## TECHNICAL NOTE

No. 505-01

: Studs 840 585 (M8 x 177) connecting cylinders

: Motorised glider engines type 505, engine no. 3,332.580 to 3,332.689.

## Instruction for exchange of the 8 studs connecting cylinders to crankcase

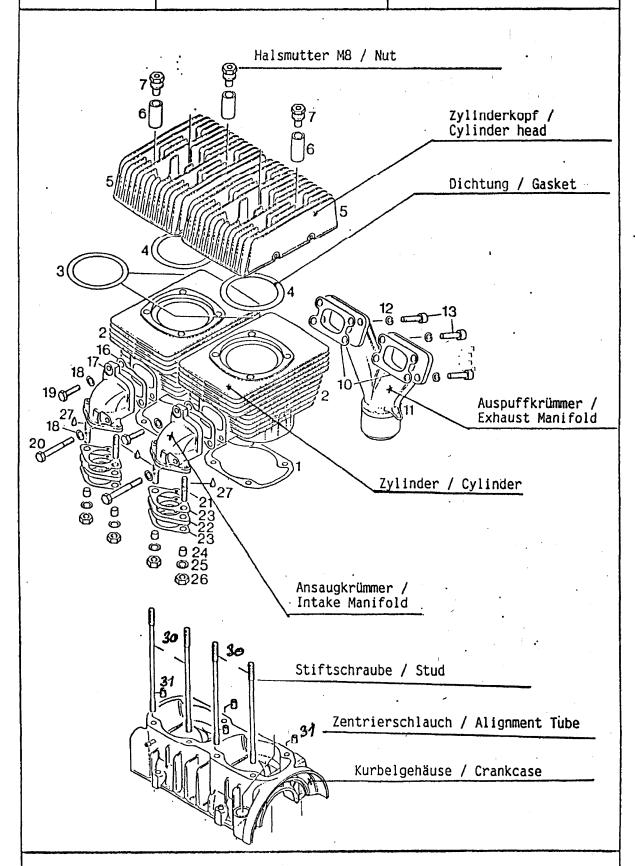
- 1) Remove socketnuts item 7 (see illustr. on page 3) diagonally and remove spacers (item 6).
- 2) Take off cylinder head. keep cylinders in position.
- 3) Remove cylinder head gaskets and if present, compression shims. Don't reuse gaskets, always exchange for new ones.
- 4) Carefully remove carbon deposits from top of piston and combustion chamber.
- 5) Exchange studs (item 30) diagonally across.
  - Attention: Insert alignment tubes (2 per cylinder, positioned diagonally). Fit studs with shorter threaded end right to bottom of tapped blind hole.
- 6) Refit cylinder heads, using new gaskets.
  - Attention: Fit nuts and compensating washers in same position as prior to disassembly.
  - Tighten socketnuts diagonally with 20 Nm.
- 7) In case of stud breakage remove any remaining parts from the tapped hole in the crankcase.
